## QUALITY ASSURANCE -- NON-CONFORMANCE REPORT

**Report No:** NCR-000523

**Reference Description:** Cope holes verified in Lift 12 were not in compliance with the approved contract drawings.

**Job Name:** SAS Superstructure

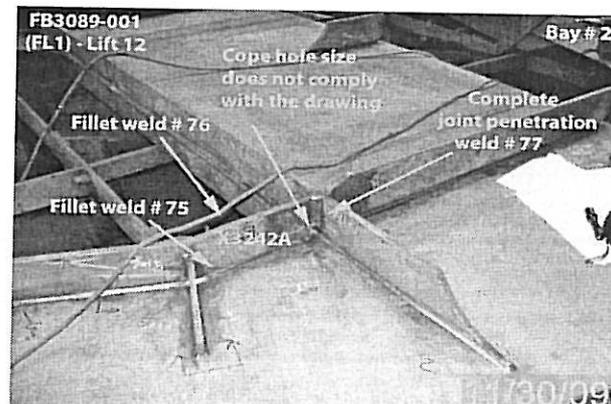
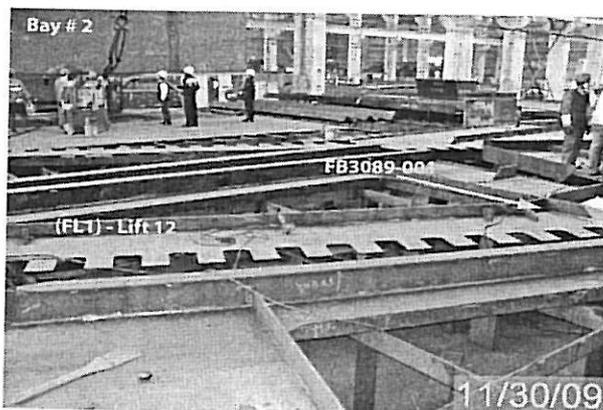
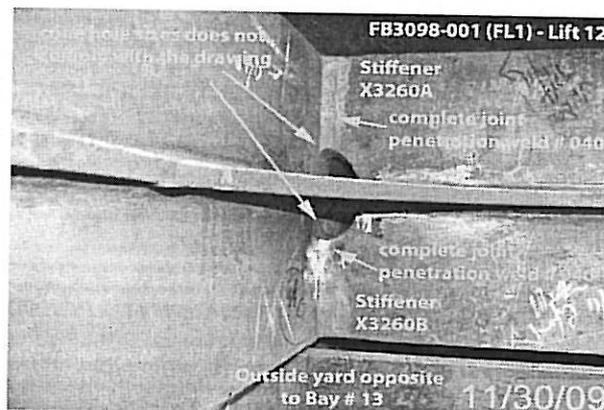
During random in process visual inspection of lift 12 FL1 OBG floor beam components this Quality Assurance Inspector (QA) observed five (5) stiffener cope-hole radii on four (4) floor beams that did not appear to comply with the dimensions specified on the approved shop drawings. The radii as measured by this QA appeared to be approximately 35 mm to 40 mm. According to the approved shop drawings the cope-hole radii should be 25mm.

FB3089-001 – Stiffener X3242A – Located at Bay # 2

FB3046-001 – Stiffener X3116A – Located outside yard opposite to Bay # 14

FB3023-001 – Stiffener X3120B – Located outside yard opposite to Bay # 14

FB3098-001 – Stiffeners X3260A &amp; X3260B – Located outside yard opposite to Bay # 13

After review, the cope holes were found to be fit for purpose as is

FLANGE PLATES ~ MARK X3120A  
(453'-10" x 465')

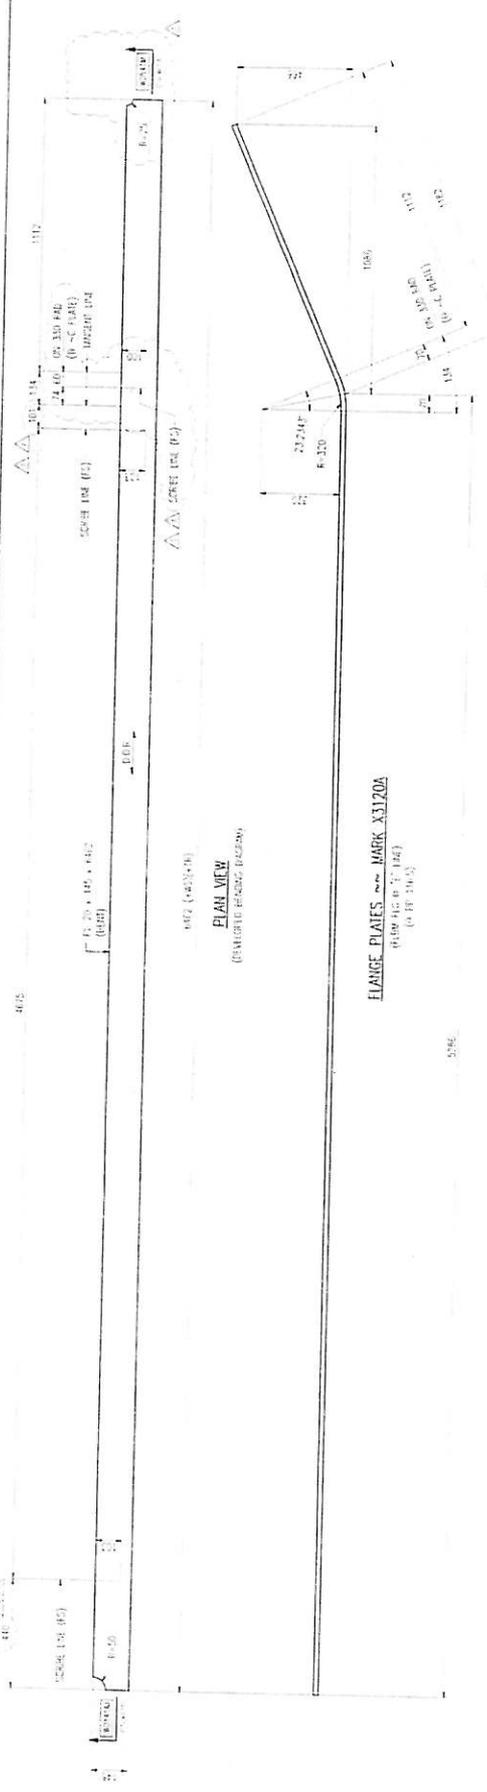
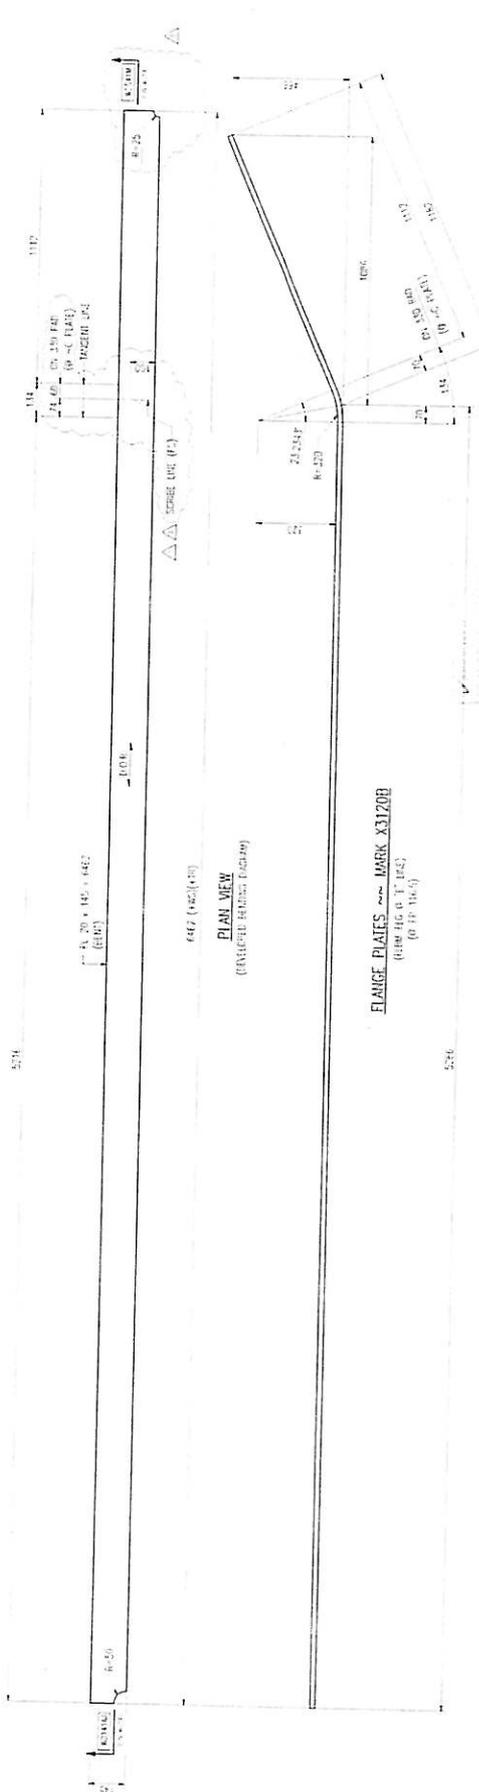
CT inspector was misreading the drawing. After confirmed with ZPMC technique department, these cope holes are not designed to be 25mm size. According to the FVT acceptance criteria what is been using now. These cope holes are all acceptable. Further, these panels are all green tagged at this moment. Attached is the designed drawing for these components, ZPMC hope CT engineer could take a review and withdraw this NCR.

DRAWING: X3120, X3116, X3260, X3242

The documentation received is sufficient to close this NCR.
